BCA ASSESSMENT REPORT

Oakdale West Estate, Kemps Creek Building 2C & 2D

**Prepared For:
Goodman Property Services (Aust) Pty Ltd**

Revision 3

Figure 2 – Perimeter Vehicular Access per BCA C2.4.

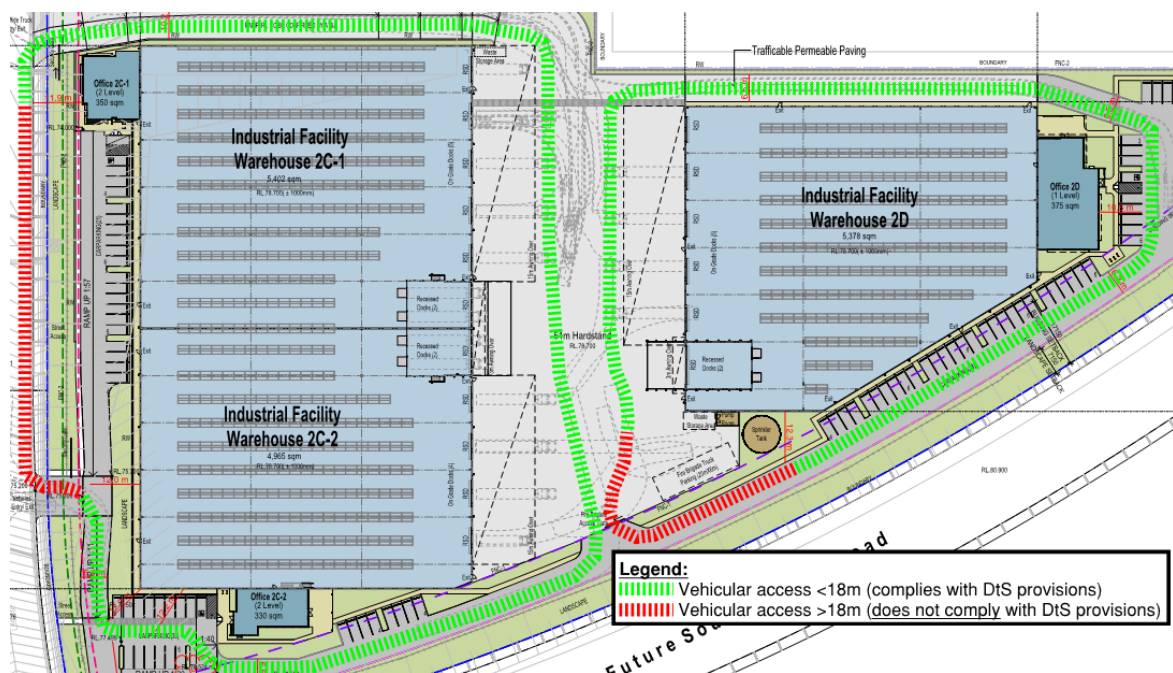
Comments: The proposed buildings do not comply with the provisions of C2.4 and thus the following non-compliance areas are identified on the site plan (over page) that are required to be addressed as an Performance Solution by the Fire Safety Engineer for each building, as follows:

- + Perimeter Vehicular Access is greater than 18m from the external walls of Building 2C & 2D as shown in the below figure, in red.

Figure 3 – Perimeter vehicle access, reduced to 5.7m in width

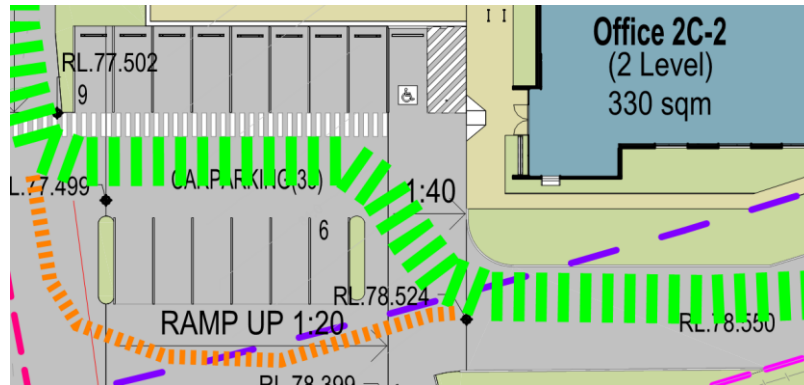
- + *Perimeter Vehicular Access incorporates a number of tight turns in the south-western car park (see below figure). Specific confirmation is required with respect to the below from the relevant consultant. Compliance is to be confirmed prior to the issue of the relevant CC.*

Note that the vehicular path further south (shown in orange) does not comply with C2.4 and thus has not been relied upon. The orange path is >18m from the building external wall, and incorporates a path less than 6m wide.

Note 2: If the perimeter access paths are reduced to less than 6m in width to accommodate pedestrian egress paths per Clause D1.10 below, this will need to be documented in the Performance Solution.
